# Access Compliance Report

## Public Rights-of-Way

Intersection ID: 14535	Main Street: E_KINGSTON_AV	Cross Street: LENNOX_AV	Location: S
ADA ID: 71257009DA66	Ramp Type: Perp	Initial Pass/Fail: Fail	Overall Compliance: No
Codes/Mitigation Info/Possible Solution		Field Measurements/Component Compliance	
Severity Score: 28.75

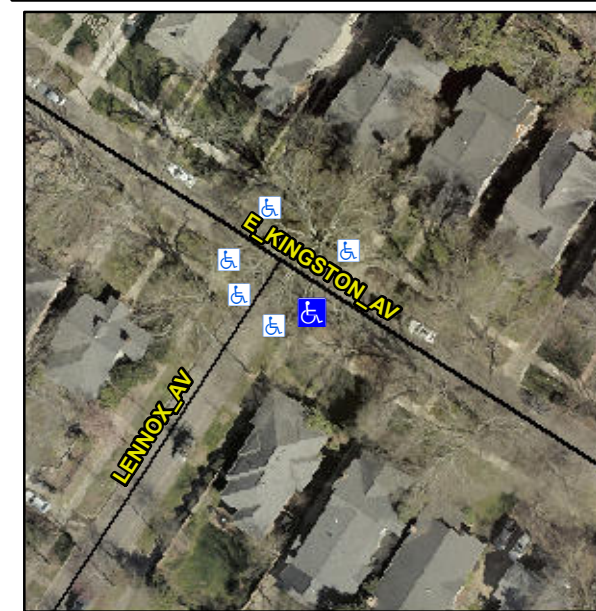
**Not Found, R304.2.2, R302.7**

Compliance	Description	Data	Compliance	Description	Data
N/A	Ramp Length (in)	72.0	No	Ramp Slope (%)	9.4
Yes	Ramp Width (in)	48.0	Yes	Ramp XSlope (%)	2.1
N/A	Flare Type LT	N/A	N/A	Flare Type RT	N/A
N/A	Flare Slope LT (%)	N/A	N/A	Flare Slope RT (%)	N/A
N/A	Flare Traversable LT?	N/A	N/A	Flare Traversable RT?	N/A
N/A	Landing Length (in)	N/A	N/A	DWS Provided?	N/A
N/A	Landing Width (in)	N/A	N/A	DWS Contrast?	N/A
N/A	Landing Slope (%)	N/A	N/A	DWS Length (in)	N/A
N/A	Landing X Slope (%)	N/A	N/A	DWS Full Width?	N/A
N/A	Landing Curb? (Y/N)	N/A	N/A	DWS Offset (in)	N/A
N/A	Shared Landing?	N/A			
N/A	Gutter Ponding?	N/A	N/A	Gutter Slope (%)	N/A
N/A	Gutter Lip Ht (in)	1.0	N/A	Gutter X Slope (%)	N/A
N/A	Painted X Walk1?	No	N/A	Painted X Walk2?	N/A
	X Walk 1 Direction	To NE		X Walk 2 Direction	N/A
N/A	X Walk 1 Width (in)	N/A	N/A	X Walk 2 Width (in)	N/A
	X Walk 1 Slope (%)	5.3		X Walk 2 Slope (%)	N/A
	X Walk 1 X Slope (%)	3.3		X Walk 2 X Slope (%)	N/A

N/A	Ramp inside XWalk1?	N/A	N/A	Ramp inside XWalk2?	N/A
	Road Slope (%)	N/A	N/A	Clear Space?	N/A
	Road X Slope (%)	N/A	N/A	Clear Space to XWalk (in)	N/A
N/A	Any Obstructions?	N/A	N/A	Storm Grate/Utility Hazard?	N/A
	Obstruction Type			Storm Grate/Utility Type	
		N/A			N/A
		No		Surface Condition? (G/P)	Poor

**Remove & Replace Entire Ramp.**
